Access Compliance Report

Public Rights-of-Way

(Pedestrian Signals)

Intersection ID: N/A	Main Street:	Cross Street: N/A	Location: N/A
ADA ID: BB97E19F04BD	Signal Type: One Push Button-APS	Overall Compliance: No	Severity Score: BTN 1: N/A BTN 2: N/A No BTN: N/A
Codes/Mitigation Info/Possible Solution		Field Measurements/Component Compliance

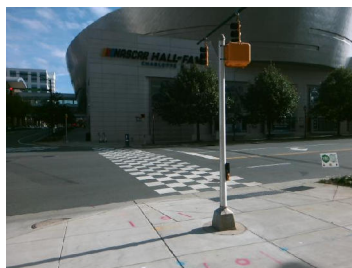
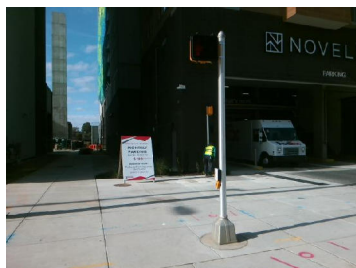
Surveyor Notes: DIST. BETWEEN ADDI. BUTTON IS 360.0 IN

PROW/ADA: R209.1, TMUTCD 4e.08, R406.2, TMUTCD 4e.10, MUTCD 4e.10

Possible Solutions: Replace Signal Push Button With APS Button on New Post. Remove & Relocate Sign.
